LaSalle County Station, Units 1 and 2
Facility Operating License Nos. NPF-11 and NPF-18
NRC Docket Nos. 50-373 and 50-374

Subject: Supplement to a Request for Approval of an Unreviewed Safety Question concerning the assessment of certain safety-related concrete block walls at LaSalle County Station, Units 1 and 2.

RESPONSE TO REQUEST FOR ADDITIONAL INFORMATION

Figure A-1 General Vicinity of the MSL Break

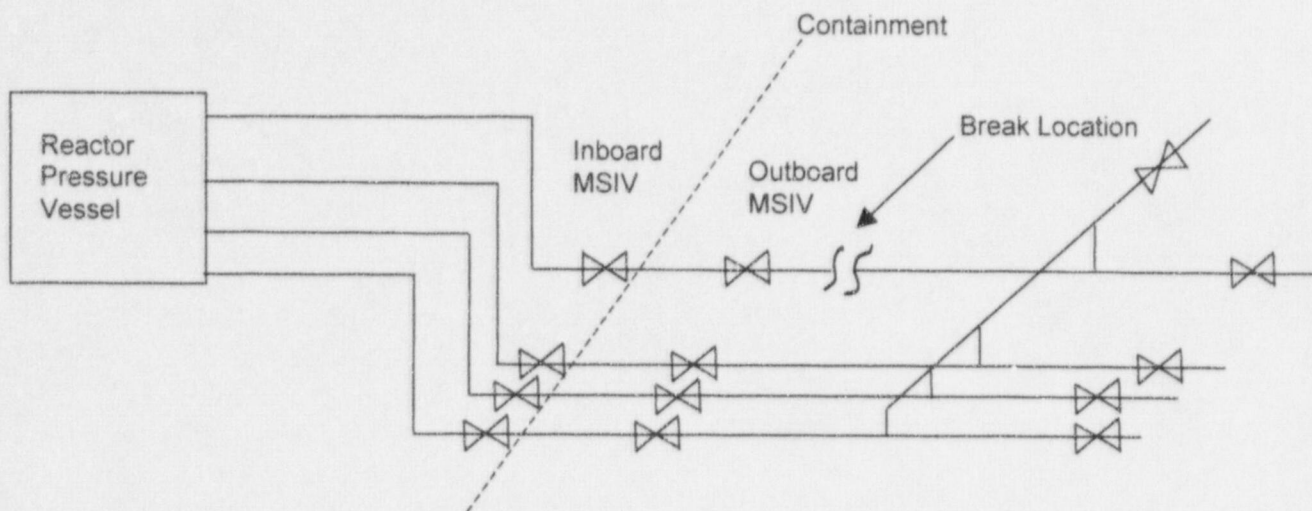
3. In Attachment G, Table O4.6, you tabulated mass and energy releases, which are used for the transient high energy line break pressurization analysis. Please provide additional information that was used for the calculation of the forward steam, reverse steam, liquid, and reverse liquid values in the table. The information should include initial conditions, assumptions, break sizes, flow models, basis for the flow stop times (such as isolation valve closure times), and the basis for the flow starting time when it is not zero.

Figure A-1 shows the piping configuration inside the Main Steam Tunnel (MST). The MSIV valves require 5 seconds to close following receipt of the break detection signal. It is assumed that the detection signal requires 0.5 seconds following the break event. Therefore the total isolation time following the break event for the MSIV is 5.5 seconds. There is a flow limiter upstream of the inboard MSIV, however for simplicity the flow limiter and the inboard MSIV are assumed to be in the same location.

The MSIVs will start to close following detection of a break. It is assumed that the flow area through the valve changes linearly as a function of time. However the area through the flow limiter is less than the valve area, therefore the critical flow rate will be controlled by the flow limiter until the valve area due to closing is less than the area of the flow limiter. These values are calculated and can be seen with the following diagram and equation, where A_p is the free flow area of the main steam line, A_l is the free flow area of the flow limiter, and t_i and t_c were previously defined as the time at which the MSIV open area equals the flow limiter open area, and the time at which the MSIV is completely closed respectively.

FIGURE 1 - TYPICAL MASONRY WALL INTERIOR COLUMN DETAIL
(REFERENCE DWG. NOS. A-64 & A-65)

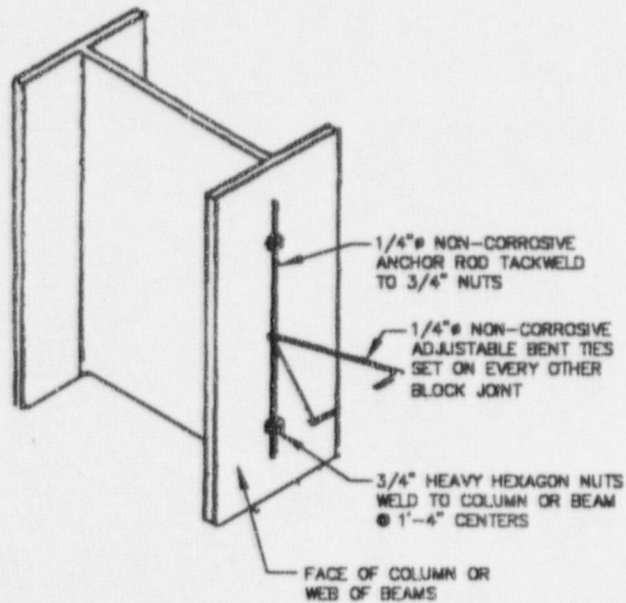
- d. a sketch that details the typical connection between the masonry blocks and the steel column, including the horizontal truss reinforcement;

A sketch of the typical connection between masonry blocks and a steel column (including horizontal truss reinforcement) is given in Figure 1 (Attachment B).
